SUBJECT: Letter Solicitation SPRTA1-25-Q-0394

ENGINEERING ORDER						1. ENGINEERING ORDER NO. 2011C1186-T				
						DATE: 2010-09-17		PAGE 1 OF 3 PAGES		
2. DWG TITLE MOTOR-GENERATOR, HYDRAULIC EMERGENCY ELECTRICAL POWER				3. DWG CAGE CODE 93835		4. DWG NO. 63038-08

1. ENGINEERING ORDER NO.
2011C1186-T

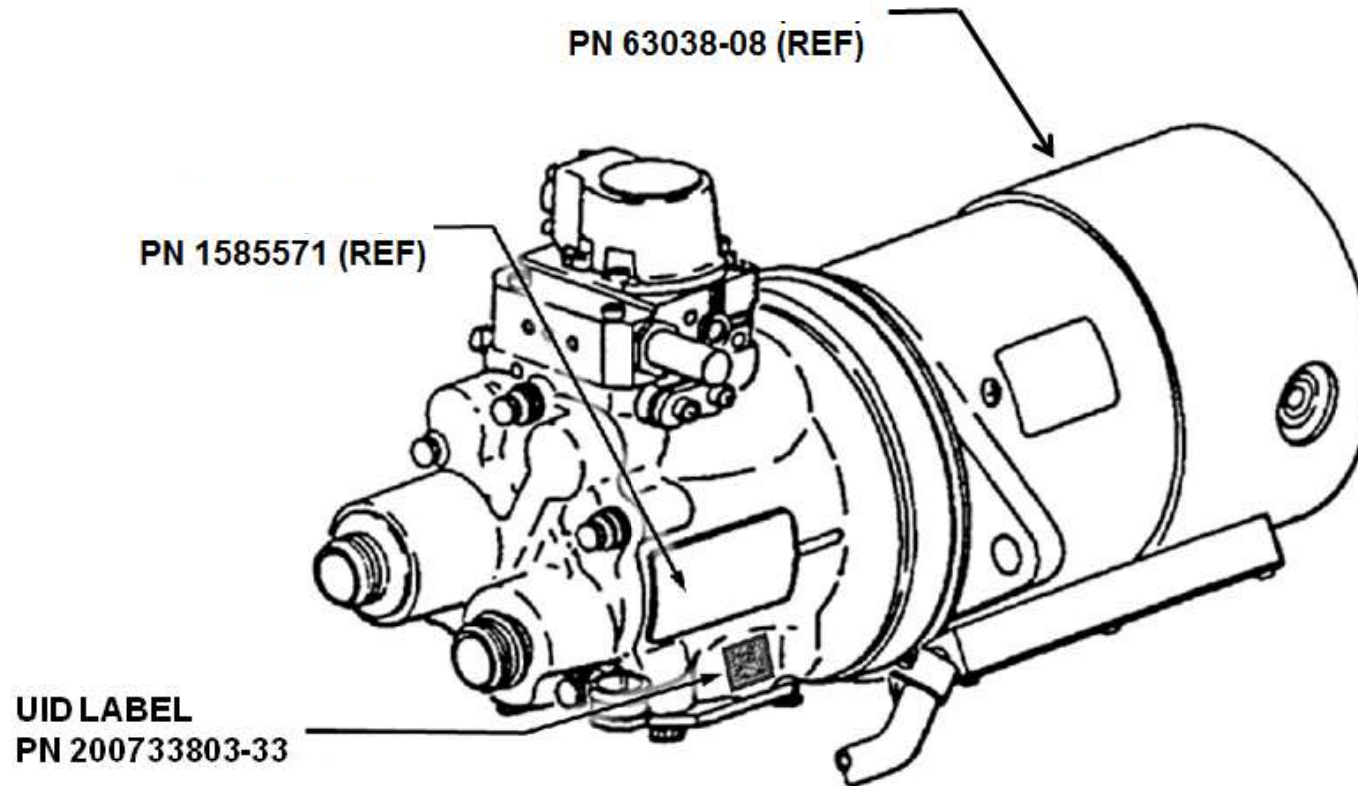
20. DESCRIPTION OF CHANGES/REMARKS										
- As of the date of this EO (17 Sept 2010), no copy of this drawing exists in JEDMICS. - F-15 Aircraft Emergency Electrical Power Hydraulic Motor-Generator (PN 63038-08) shall be marked with a Unique Item Identifier (UII). (REF: MIL-STD-130) - If no UID label is present, fabricate new UID label (200733803-33) to attach to the end item (PN 63038-08). - New UID label will be located on the end item as shown in sketch/photo on page 2, AF form 3926. (UID Label P/N 200945085-013A is an acceptable alternate part)
